**To:** Planning Committee **Date:** June 19, 2002  
**From:** Joe Erceg **File:** RZ 01-198910  
Manager, Development Applications  
**Re:** **APPLICATION BY GRANDSPAN DEVELOPMENT LTD. FOR REZONING AT  
4791 STEVESTON HWY. FROM SINGLE-FAMILY HOUSING DISTRICT,  
SUBDIVISION AREA E (R1/E) TO COMPREHENSIVE DEVELOPMENT DISTRICT  
(CD/135)**

## Staff Report

SITE PLAN

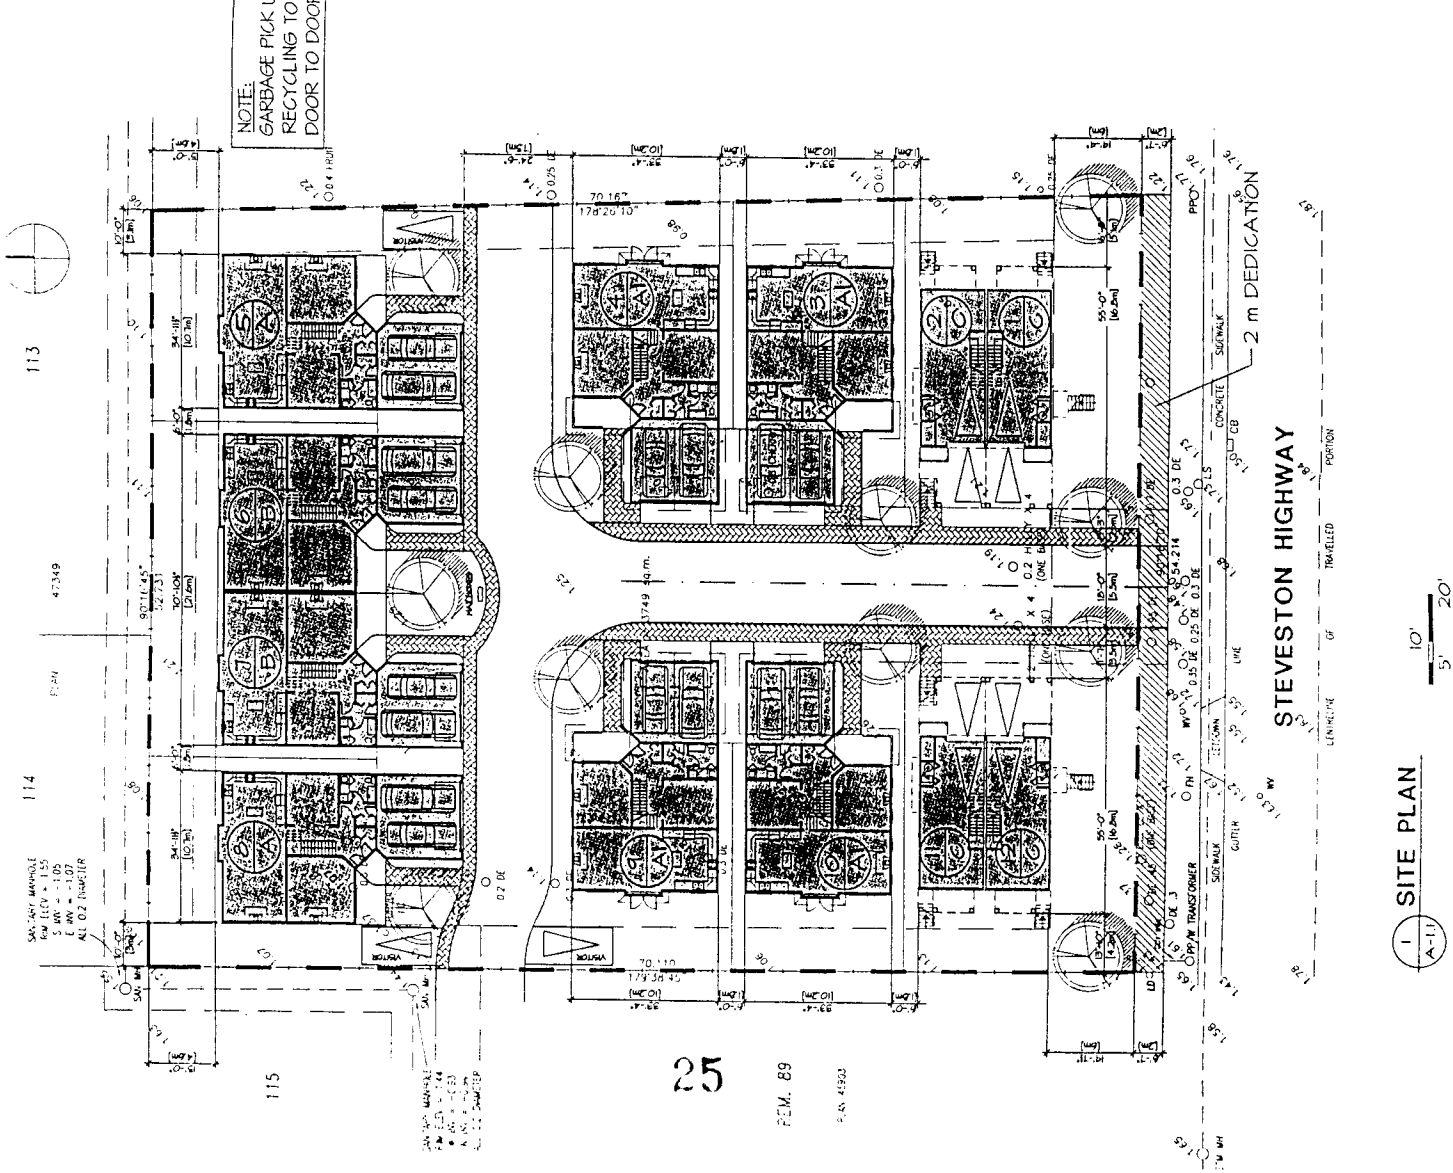
The comments below are based upon the applicant's site plan dated May 24/02 showing 12 units on strata title, 8 units single family character and 2 duplexes (4 units). These design related comments can be addressed through the Development Permit application/servicing agreement stage or earlier. The applicant should:

- Show turnaround capability for all three of the visitor parking stalls (e.g. hammerheads);
- Remove bulge around the mailbox area that encroaches into the laneway;
- Ensure only one vehicular access to Steveston Hwy.;

- Design and provide a “driveway” crossing at Steveston Hwy.;
- Note that for travel lanes, 5.5 m acceptable, however additional width may be required for other purposes (e.g. utilities, lighting, etc);
- Provide a 2 m road dedication required along Steveston Highway;
- Provide a sidewalk that is separated from the travel lanes.
